Realisation of ATC to Lelystad (EHLE) – independent review of project timelines (as of 6th February 2017)

This review of the project to introduce ATC services at Lelystad Airport is based on a request to look specifically at the schedule, and determine if the revised planning towards an April 2019 operational date is achievable, realistic and resilient.

Figure 3: Timelines for technical AAA system development

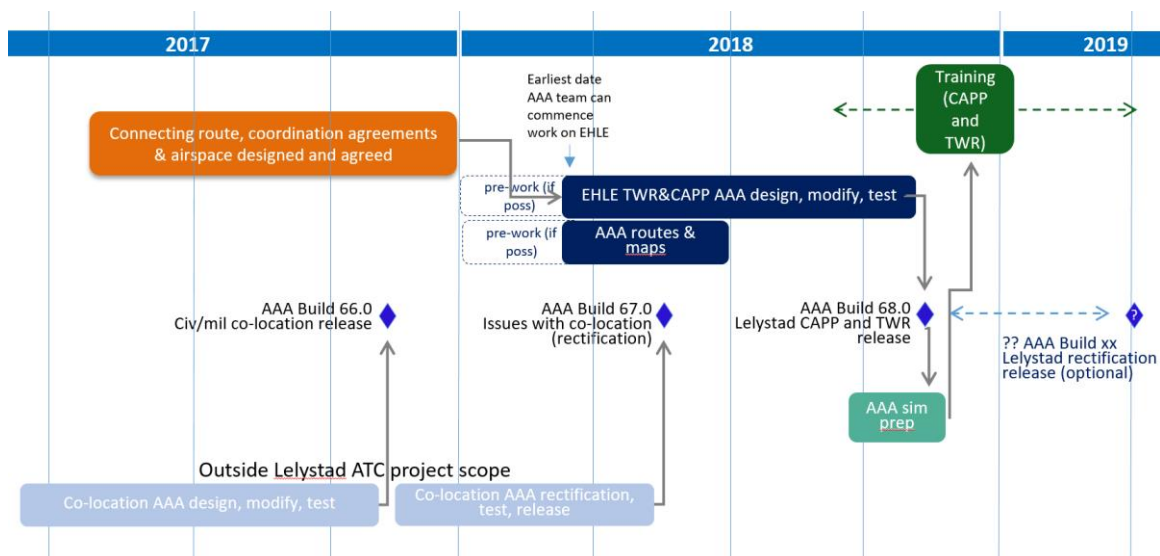
The planning for the AAA build calls for a delivery of Co-location AAA (66.0) by end of 2017, a single rectification build for Co-location AAA (67.0) six months later, and a delivery of Lelystad AAA CAPP and TWR (68.0) by November 2018. There are several smaller repair builds planned within these timelines. This schedule is then on the critical path for the simulator development and subsequent training, as shown in Figure 3.

A further Lelystad AAA CAPP and TWR rectification release is optionally planned early in 2019.

A further risk lies in the planning for a single rectification release. In the review team's experience, a late change in requirements for controller acceptability can often occur, particularly when dealing with multiple stakeholders. A second rectification release may be required to address these; the scenario and planning for this should be assessed to understand what risk it would pose to the schedule for Lelystad ATC.

The review team questioned whether the lack of a rectification build for AAA Lelystad CAPP and TWR is justifiable in terms of experience, recent history and best practice. If a rectification build were required, it would almost certainly push back the operational date. There would be operational restrictions, due to less automation, more handwork and more verbal communication between TWR and CAPP.

- the planned start on Lelystad CAPP and TWR (~Mar 2018) is at significant risk from the co-location rectification build (due for release May 2018) and other projects across LVNL using software team resource; the plan appears vulnerable at this point;

- the lack of a rectification build for Lelystad AAA CAPP and TWR in the core planning is a concern; the review team recognises that the next step on the critical path (simulator and training exercise development and implementation) could proceed with the initial build, but also notes that any changes could require re-work and re-training;

2. In all aspects of AAA development, there is no margin in the planning. For true confidence in the schedule, LVNL could explore adding more margin, potentially planning for a second rectification build of AAA CAPP (co-location) and/or a single rectification build of AAA Lelystad CAPP and TWR. (**Internal** recommendation)

Figure 4: Project timelines and critical path (version 1: LVNL)

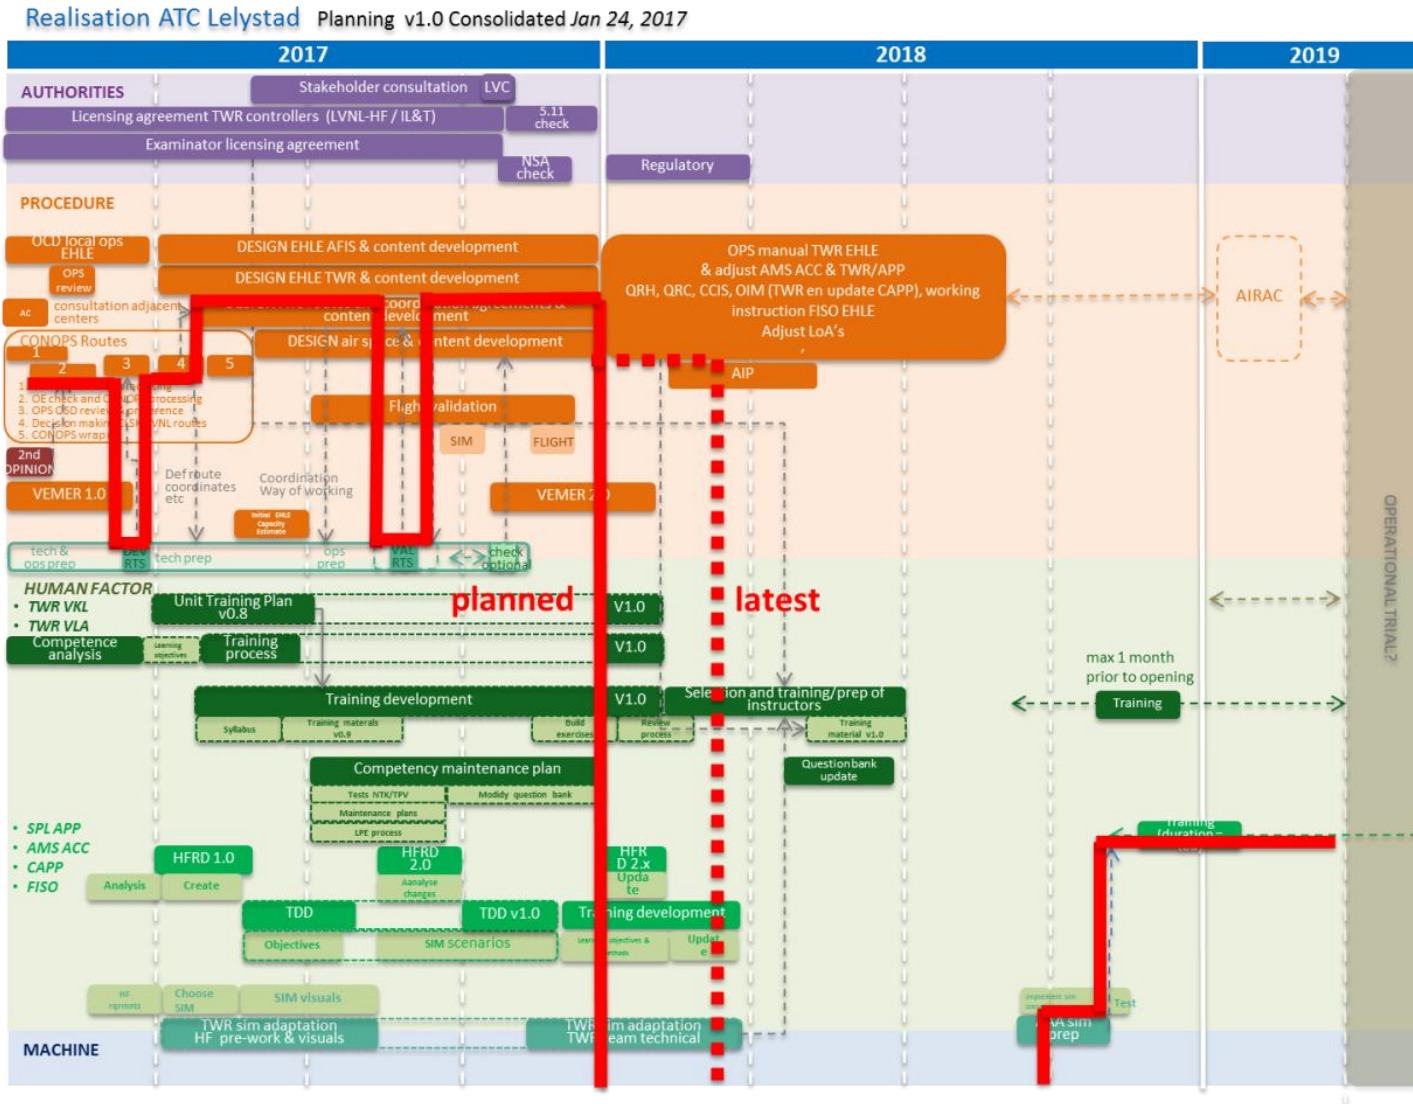
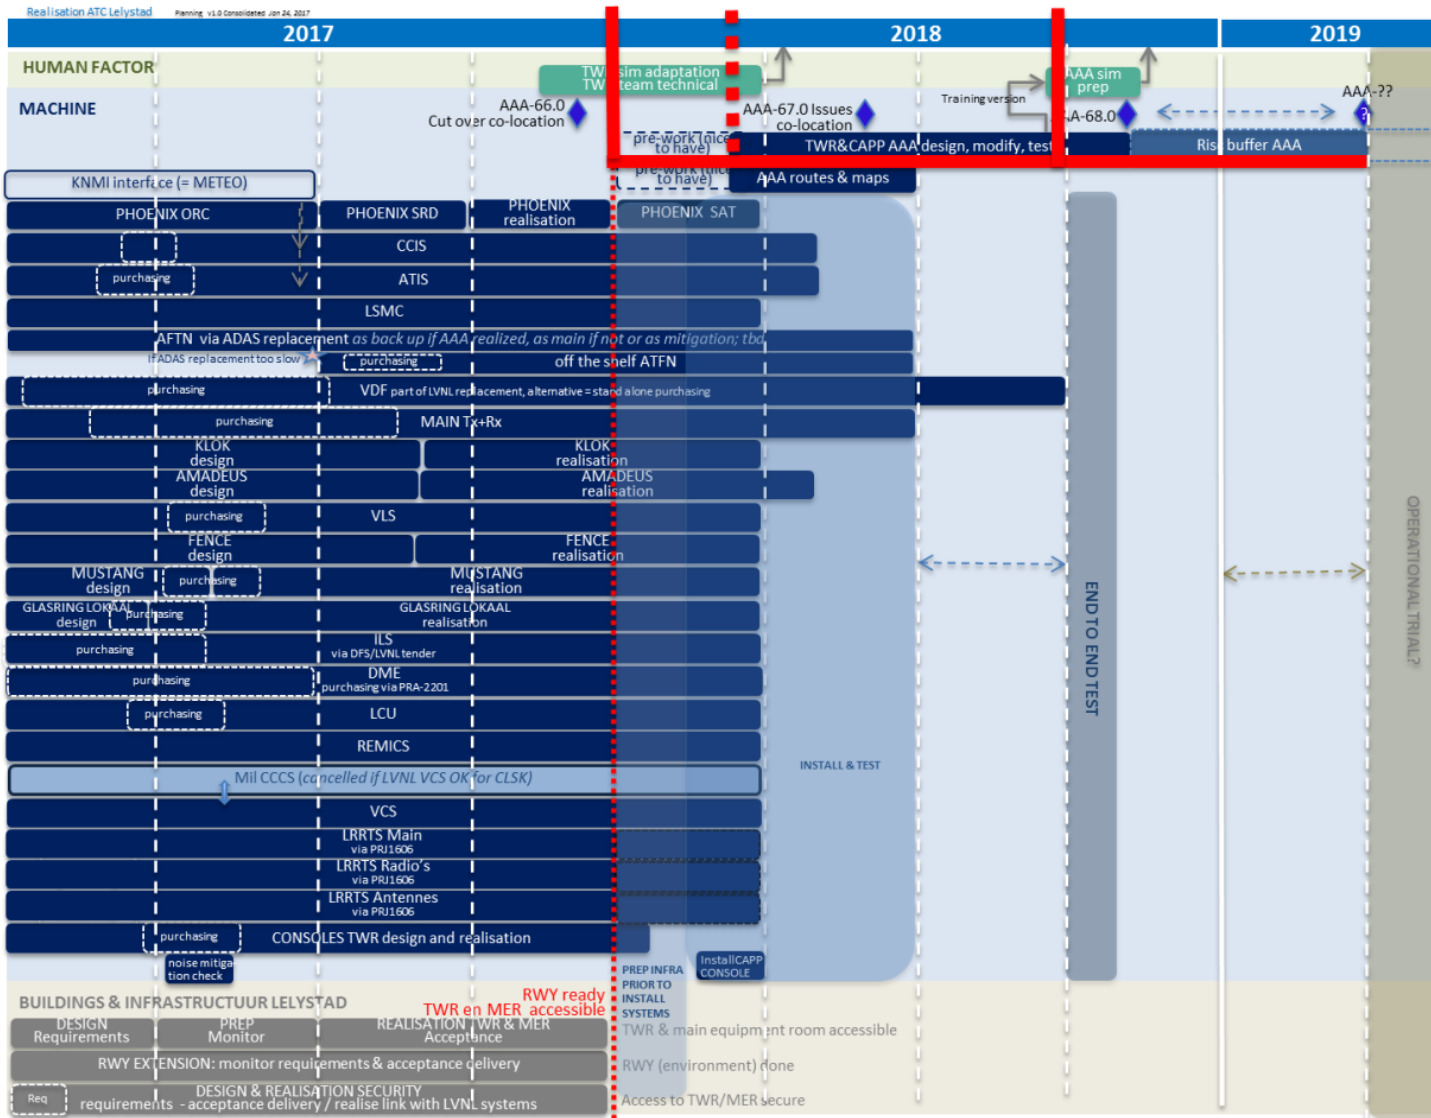
The core of the change process is overseen by the project management tasks across the lifecycle of the change. The planned schedule is captured in the Gantt chart in Figure 4, section 6, and the planning process and detail can be tested to give confidence that the critical path identified will be followed.

There has been an additional Real Time Simulation (RTS2) recently added to the schedule with a proposal for another. This back-up RTS would also lie on the critical path. RTS2 is still to be precisely scheduled, but is planned to be prior to October 2017. It may pose issues for availability of operational staff, particularly as the co-location project is also proposing to use simulator time during this period. Schedules are being closely monitored and planned between the Lelystad ATC project manager and military lead.

Consensus between LVNL and CLSK on the concept design is planned for May 2017, taking account of the LVNL workload modelling, MME modelling, and the RTS1 results. This then allows a range of other steps reliant on the concept design to begin, including formal procedure design, flight validation, stakeholder consultation and training design. This critical connected step is a high concern for the timeline.
